QUALITY ASSURANCE -- NON-CONFORMANCE REPORT

Report No: NCR-000788

Bridge No: 34-0006

Component: West Shaft: Lift 2 Gusset Plate

-The weld is identified as WSD1-SA340B/F-16.

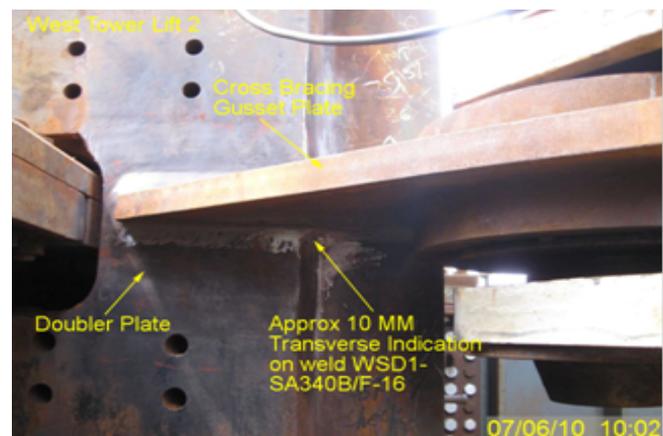
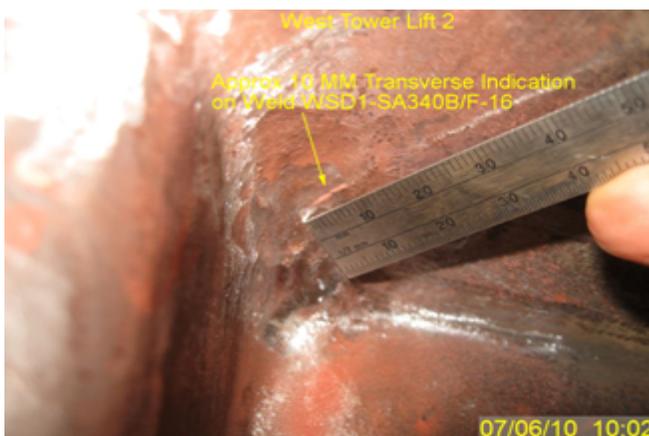
During Magnetic Particle Testing (MT) review of welds on West Tower Lift 2, Caltrans Quality Assurance Inspector (QA) discovered the following issues:

-One transverse indication (crack) measuring approximately 10mm in length in PJP weld between gusset plate and doubler plate

The Notice of Witness Inspection Number (NWIT) is #06134. The indication is located within the area that has been previously tested and accepted by ZPMC Quality Control (QC) personnel. As per Contract, 100% MT inspection is required for this weld.

ZPMC has repaired the indications missed and is submitting the CWR and NDT used at the time. ZPMC has discussed this issue with both their inspectors and productions staff to eliminate the indications during production and also after during inspection. Based on this ZPMC requests closure of this NCR.

This proposed resolution is acceptable. The documentation received is sufficient and the Department concurs that Non-Conformance ZPMC-0750 is closed.

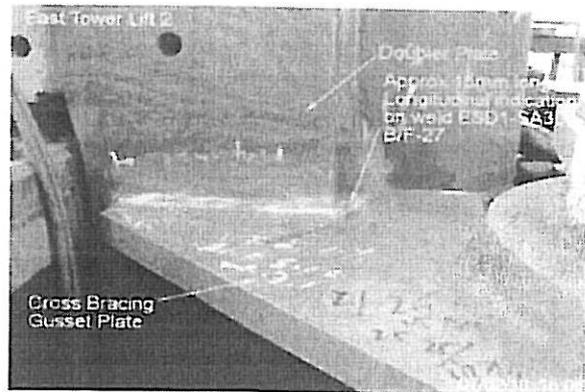
During Magnetic Particle Testing (MT) review of welds on East Tower Lift 2, Quality Assurance Inspector (QA) discovered the following issues:

- One Longitudinal crack indication measuring approximately 15mm in length.
- The member is identified as Cross Bracing gusset plate to Doubler plate
- The weld is identified as ESD1-SA300B/F-27.
- The weld is a Partial Joint Penetration (PJP) weld, joining the Cross Bracing gusset plate to Doubler plate.

The Notice of Witness Inspection Number (NWIT) is 06106. The indication is located within the area that has been previously tested and accepted by ZPMC Quality Control (QC) personnel. As per the contract documents, ZPMC's QC personnel are required to perform 100% MT inspection of this weld.

ZPMC realized this problem, and put forward T-CWR664 and T-CWR669 at the first time for repairing. Finally these relevant welds were fixed and checked by MT. Also they were re-inspected by CT inspector and green tagged. Here attached the related documents to prove the welds are sound after repairing.

项目名称 Project Name:	美国海湾大桥 SFOBB	部件图号 Drawing No.:	ESD1-SA300B/F	报告编号 Report No.:	T-CWR664
合同号 Contract No.:	04-0120F4	部件名称 Item Name:	东二吊53米十字撑 补板Tower(E) 2 nd 5 3m strut plate	NDT 报告编号 NDT Report No.:	NA
项目编号 Project No.:	ZP06-787

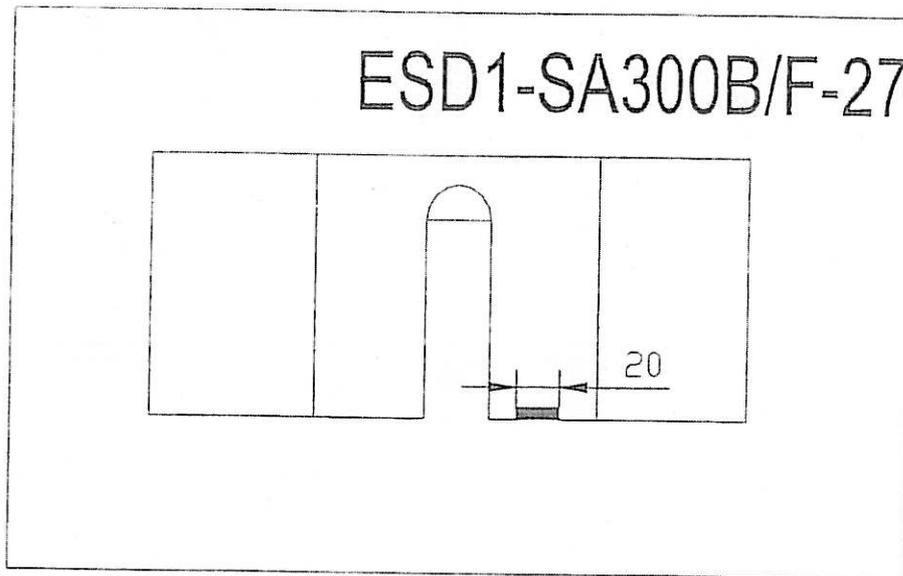
The crack was found at east tower 2nd lifting strut plate weld (ESD1-SA300B/F-27), and need to repair.

1. 火焰加热时, 水汽没有完全的去除或者这个区域预热不够;
1. Moisture wasn't completely removed during drying operation (preheating) or the area wasn't preheated sufficiently.

1. QC /CWI shall monitor and direct all gouging, grinding and welding during the repair procedure.
2. Remove defects by gouging and /or grinding. If gouging is used, preheat the repair area to a minimum temperature of 65°C.
3. Prepare excavation according to the approved repair WPS.
4. Grind the repair area to a smooth and shiny surface.
5. Verify that no defects are present by VT and MT prior to weiding.
6. Clean excavation of all loose debris and MT powder.
7. Weld according to the approved WPS.
8. Preheat and maintain interpass temperature control in accordance to the approved WPS.
9. QC shall ensure all slag has been removed prior to the deposition of the next pass.
10. Blend the weld repaired areas into the adjacent weld or base metal by grinding.
11. Perform VT, MT and UT inspection to the repaired areas.

1. QC shall verify sufficient preheat has been applied, to remove moisture, prior to welding.

-The weld is identified as WSD1-SA340B/F-16.

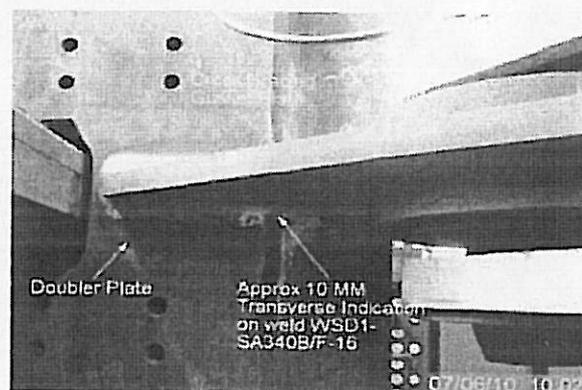
During Magnetic Particle Testing (MT) review of welds on West Tower Lift 2, Caltrans Quality Assurance Inspector (QA) discovered the following issues:

-One transverse indication (crack) measuring approximately 10mm in length in PJP weld between gusset plate and doubler plate

The Notice of Witness Inspection Number (NWIT) is #06134. The indication is located within the area that has been previously tested and accepted by ZPMC Quality Control (QC) personnel. As per Contract, 100% MT inspection is required for this weld.

ZPMC has repaired the defects, submitted CWR and NDT reports confirming the results of the repair. ABF has discussed with the personnel involved to take appropriate actions to prevent similar occurrence in future.

项目名称 Project Name:	美国海湾大桥 SFOBB	部件图号 Drawing No.:	WSD1-SA340B/F	报告编号 Report No.:	T-CWR669
合同号 Contract No.:	04-0120F4	部件名称 Item Name:	西二吊53米十字撑 补板Tower(w) 2 nd lifting 53m strut plate	NDT 报告编号 NDT Report No.:	NA
项目编号 Project No.:	ZP06-787

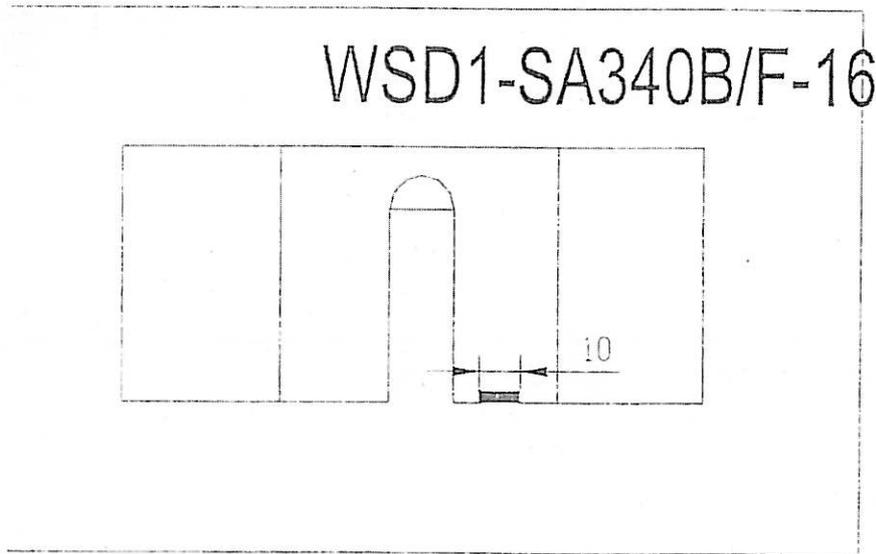
The crack was found at west tower 2nd lifting 53m strut plate weld WSD1-SA340B/F-16, 10mm in length, and needed to repair.

1. 火焰加热时, 水汽没有完全的去除或者这个区域预热不够;
1. Moisture wasn't completely removed during drying operation (preheating) or the area wasn't preheated sufficiently

1. QC /CWI shall monitor and direct all gouging, grinding and welding during the repair procedure.
2. Remove defects by gouging and /or grinding. If gouging is used, preheat the repair area to a minimum temperature of 65°C.
3. Prepare excavation according to the approved repair WPS.
4. Grind the repair area to a smooth and shiny surface.
5. Verify that no defects are present by VT and MT prior to weiding.
6. Clean excavation of all loose debris and MT powder.
7. Weld according to the approved WPS.
8. Preheat and maintain interpass temperature control in accordance to the approved WPS.
9. QC shall ensure all slag has been removed prior to the deposition of the next pass.
10. Blend the weld repaired areas into the adjacent weld or base metal by grinding.
11. Perform VT, MT and UT inspection to the repaired areas.

1. QC shall verify sufficient preheat has been applied, to remove moisture, prior to welding.
